**WVSU RESEARCH AND DEVELOPMENT CORPORATION
KANAWHA COUNTY, WEST VIRGINIA
STINGER PRODUCE MARKET UPGRADES**

**ADDENDUM #2
August 13, 2026**

THRASHER PROJECT #T60-11496

1 **BELOW FLOOR PLAN - PLUMBING**
P2.00 3/8" = 1'-0"

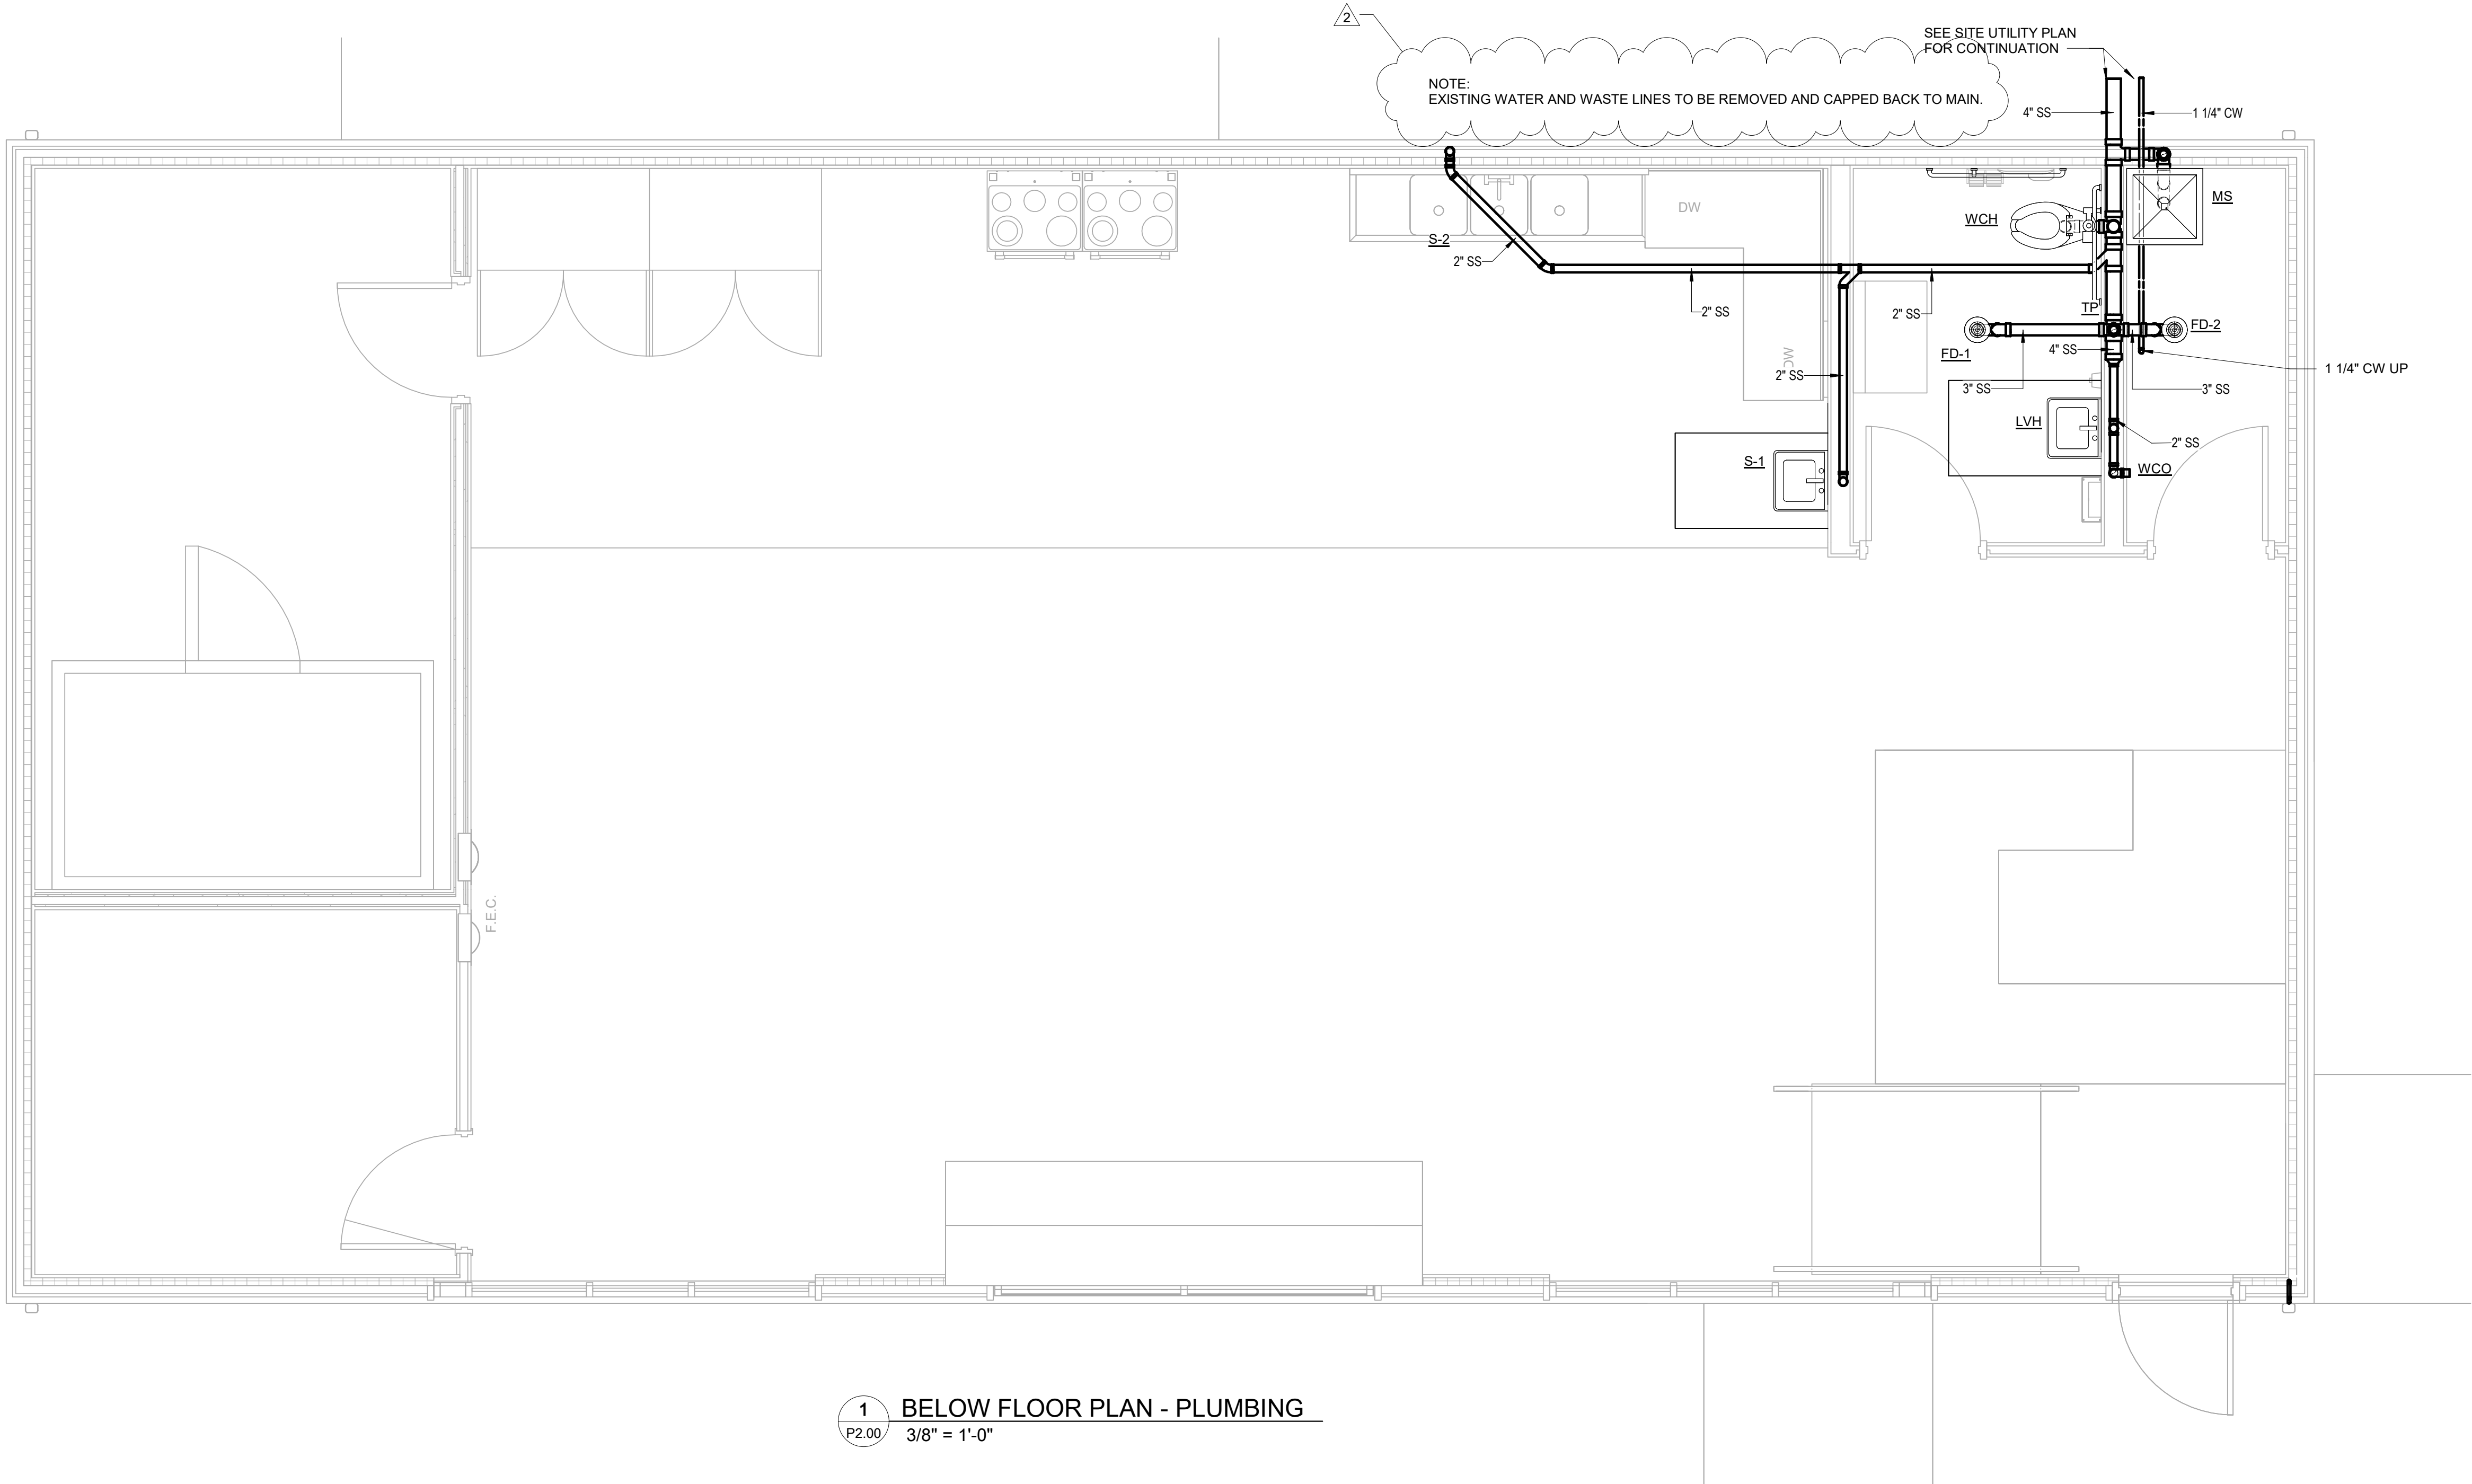
There were existing plumbing coming up through the slab, assuming these are not be reused due to Sheet P2.00 could it be clarified what is to be done with the existing piping?

See the note on the revised plan.

NEW WORK HVAC POWER PLAN -
ELECTRICAL
3/8" = 1'-0"

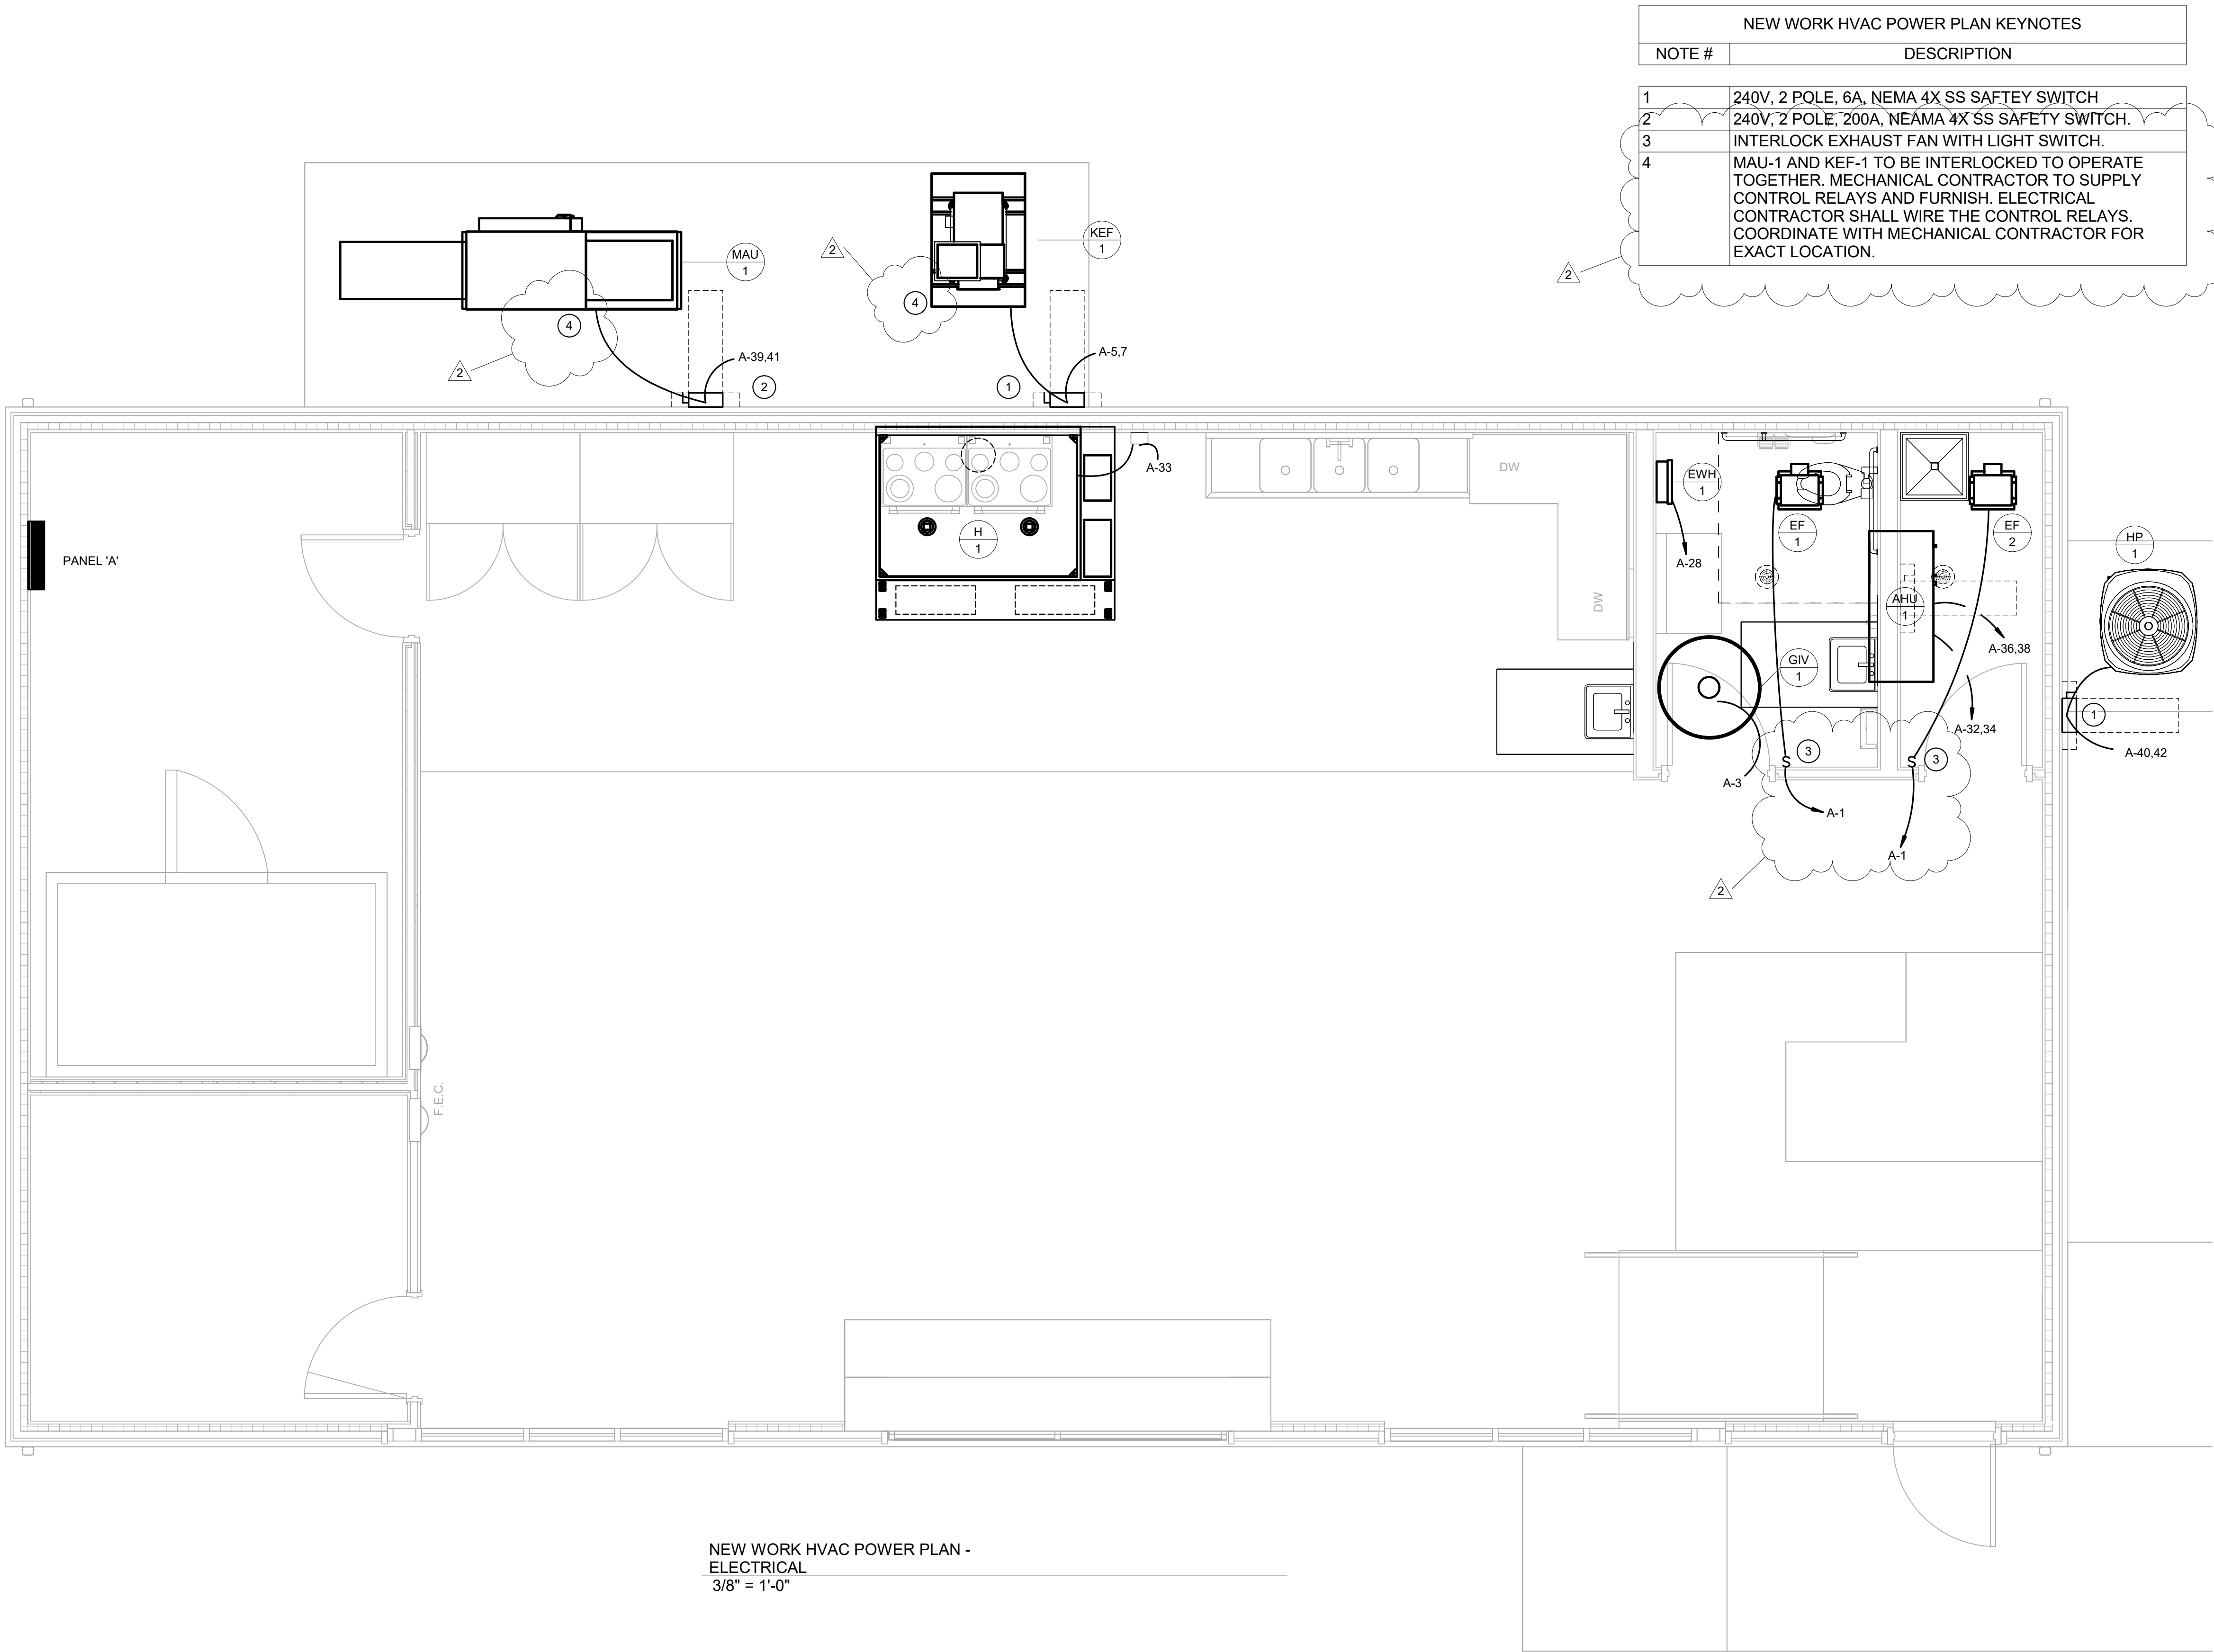
Note 14 states: "Control relays will be wired by the electrical contractor". This is not shown on the electrical drawings, please advise.

Revised in this addendum.
